Tower Q: UDCPR compliance check

Automated check of architectural drawings against selected UDCPR (Maharashtra) regulations. Report date 06 Oct 2026.

Figure 1. Extracted rooms and connections. Rooms circled in red have a FAIL or REVIEW result. Edge labels are door leaf widths or glazing widths in metres.

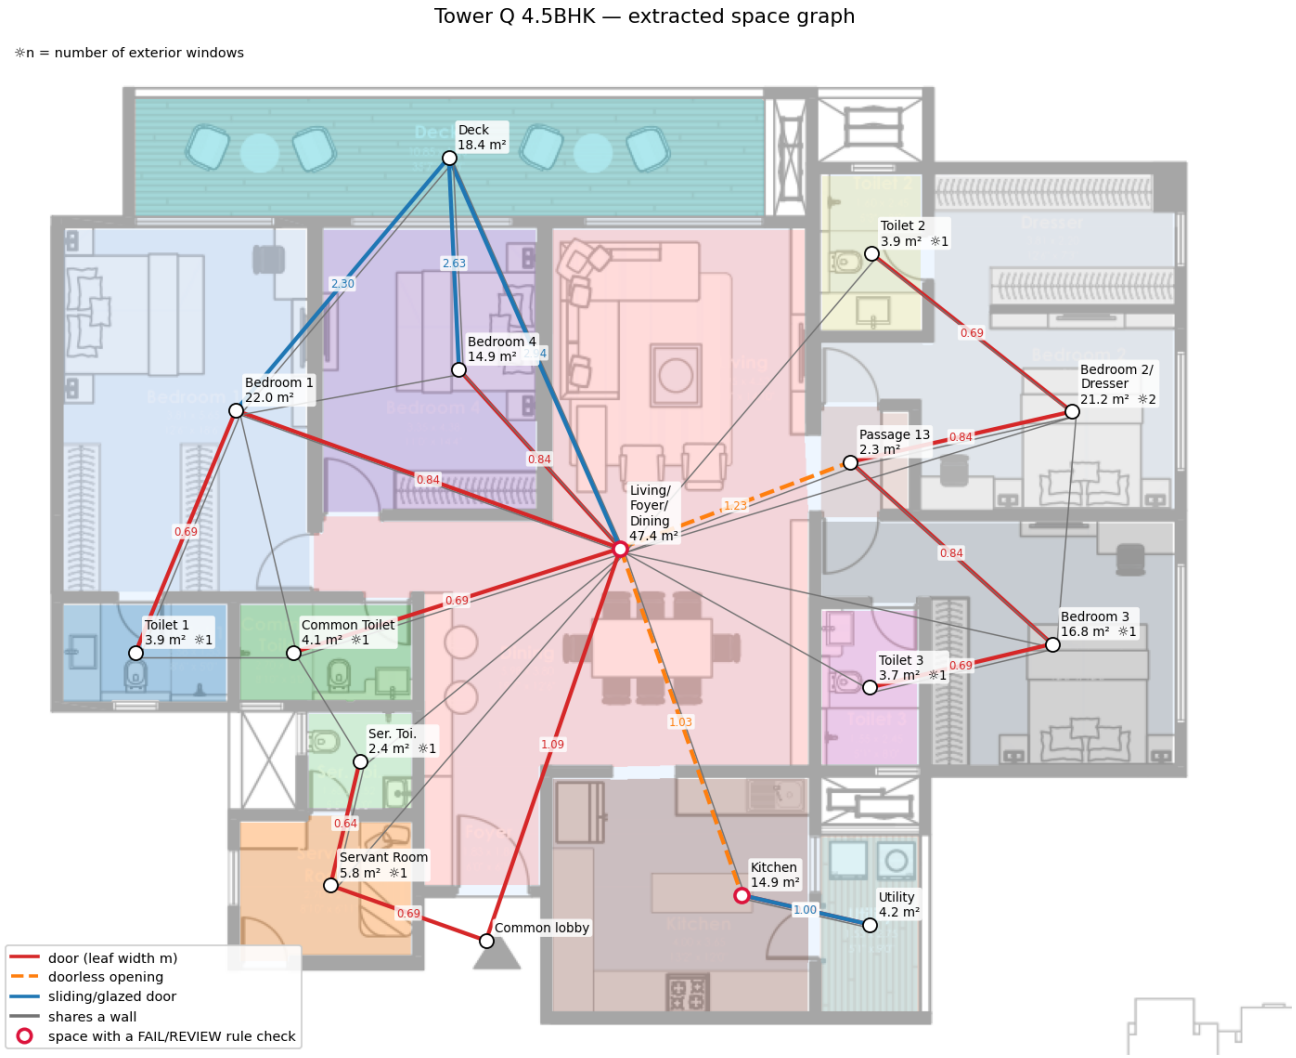
Room	Area m²	Check	Result	Detail
Bedroom 1	22.04	opening ratio	**CANNOT DETERMINE**	needs 2.20 m2 of openings (0.1 x 22.04 m2); glazed width 2.30 m, so openings must be at least 0.96 m high on average - opening head/sill heights are not in the drawing; via glazed door to Deck 2.30 m
Bedroom 1		depth	**PASS**	farthest floor point 5.7 m from the nearest opening (limit 7.5 m)
Servant Room	5.83	opening ratio	**CANNOT DETERMINE**	needs 0.58 m2 of openings (0.1 x 5.83 m2); glazed width 0.98 m, so openings must be at least 0.59 m high on average - opening head/sill heights are not in the drawing; via window to exterior 0.98 m
Servant Room		depth	**PASS**	farthest floor point 2.6 m from the nearest opening (limit 7.5 m)
Living / Foyer / Dining	47.42	opening ratio	**CANNOT DETERMINE**	needs 4.74 m2 of openings (0.1 x 47.42 m2); glazed width 2.94 m, so openings must be at least 1.61 m high on average - opening head/sill heights are not in the drawing; via glazed door to Deck 2.94 m

Room	Area m²	Check	Result	Detail
Living / Foyer / Dining		depth	**FAIL**	farthest floor point 10.5 m from the nearest opening (limit 7.5 m); 19% of the floor is beyond the limit
Bedroom 4	14.92	opening ratio	**CANNOT DETERMINE**	needs 1.49 m2 of openings (0.1 x 14.92 m2); glazed width 2.63 m, so openings must be at least 0.57 m high on average - opening head/sill heights are not in the drawing; via glazed door to Deck 2.63 m
Bedroom 4		depth	**PASS**	farthest floor point 4.3 m from the nearest opening (limit 7.5 m)
Kitchen	14.91	opening ratio	**REVIEW**	no glazing to exterior/open_deck; only glazed door to Utility 1.00 m - decide whether that space counts as a light source
Kitchen		depth	**REVIEW**	no glazing to exterior/open_deck; only glazed door to Utility 1.00 m - decide whether that space counts as a light source
Bedroom 3	16.77	opening ratio	**CANNOT DETERMINE**	needs 1.68 m2 of openings (0.1 x 16.77 m2); glazed width 2.58 m, so openings must be at least 0.65 m high on average - opening head/sill heights are not in the drawing; via window to exterior 2.58 m

Bedroom 3		depth	**PASS**	farthest floor point 5.4 m from the nearest opening (limit 7.5 m)
Bedroom 2 / Dresser	21.25	opening ratio	**CANNOT DETERMINE**	needs 2.12 m2 of openings (0.1 x 21.25 m2); glazed width 2.89 m, so openings must be at least 0.74 m high on average - opening head/sill heights are not in the drawing; via window to exterior 1.96 m, window to exterior 0.93 m
Bedroom 2 / Dresser		depth	**PASS**	farthest floor point 5.3 m from the nearest opening (limit 7.5 m)

Data needed to resolve CANNOT DETERMINE: window and door head and sill heights (elevations or a window schedule). The minimum average opening height each room needs is given in the detail column.
